# Sumter City-County Planning Commission

## MSP-15-44/HCPD-15-23, 1177 Broad St. (County)

Request: Request for Major Site Plan approval and Highway Corridor

Protection District Design Review approval for a 2695 sq. ft. Popeyes Restaurant and an 8,800 sq. ft. multi-tenant retail building

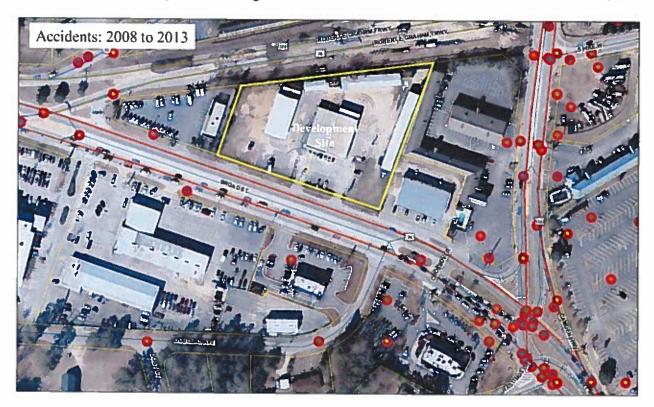
Along the Broad St. Street Landscape Buffer and for a portion of the eastern Type A Buffer, the applicant has proposed replacing the required canopy trees with understory trees on a 2 for 1 exchange. This request is based on the placement of overhead power lines along Broad St. and overhead lines that serve the adjacent parcel. Staff finds this to be a reasonable request given the conditions on-site.

As proposed, this landscape plan meets the intent of the Ordinance.

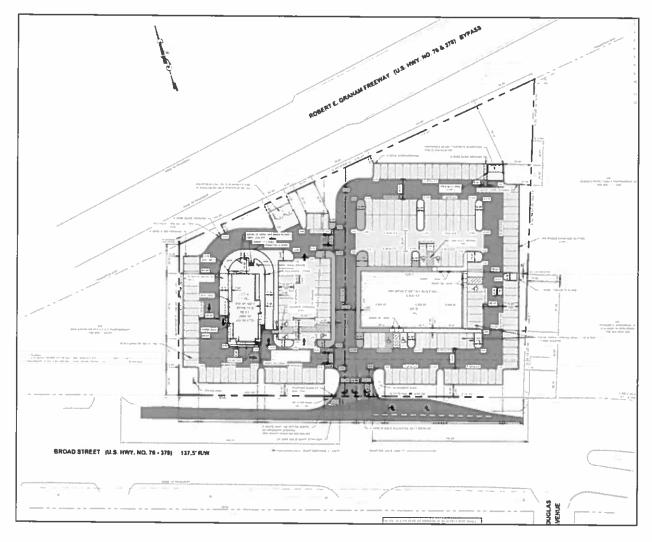
In reviewing site conditions and understanding the traffic volumes during peak periods adjacent to this site, Planning Staff is recommending the installation of a right-turn/entrance lane into the

site to help move entering traffic off of the westbound lane during peak periods. The graphic below illustrates this condition.

Planning Staff has discussed this proposal with SCDOT, and understands that DOT would permit the installation of a right-turn lane at the site entrance.

- Annexation of the property into the City of Sumter prior to construction for any portion of the development;
- Installation of right-turn lane on Broad St. at the site entrance.

PRELIMINARY MONUMENT SIGN SUMTER SHOPPING CENTER

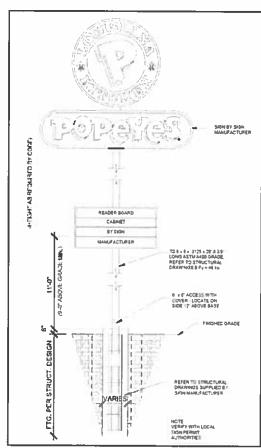
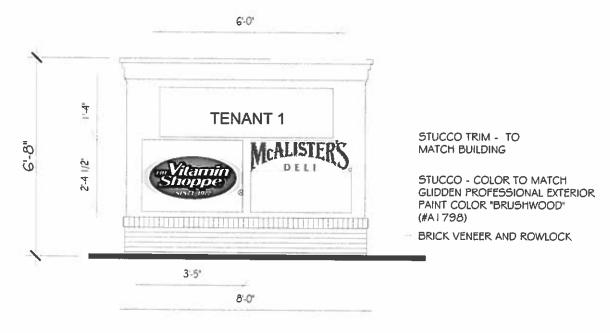
The applicant has submitted renderings of the proposed freestanding signage, however; these plans have been submitted for design

review. Upon cursory review, it appears that each sign will be capped at a total of 200 sq. ft. of sign face for each freestanding sign unit. Final sign plans shall be submitted with permit applications to calculate total size limitations.

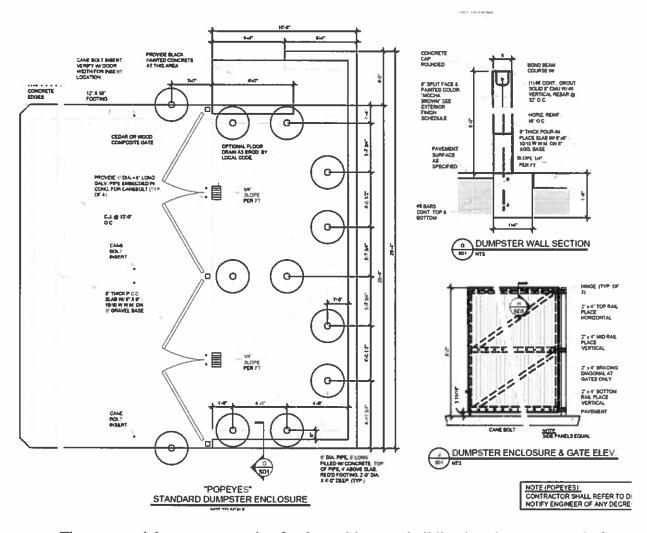
There are two identified dumpster locations on site. The dumpster dedicated for use at Popeyes will be constructed of split-fact CMU and painted a color that compliments the primary structure as shown in the screening detail on the following page.

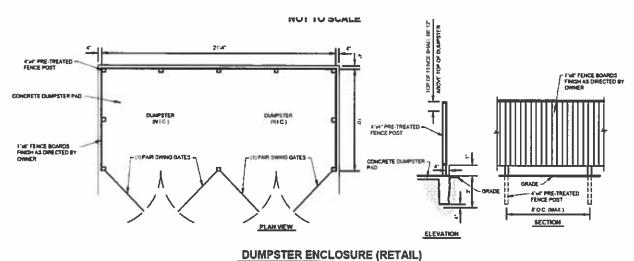
The proposed dumpster screening for the multi-tenant building is to be constructed of wooden privacy fencing, located behind the building. A fencing detail of the proposed screening is shown below.
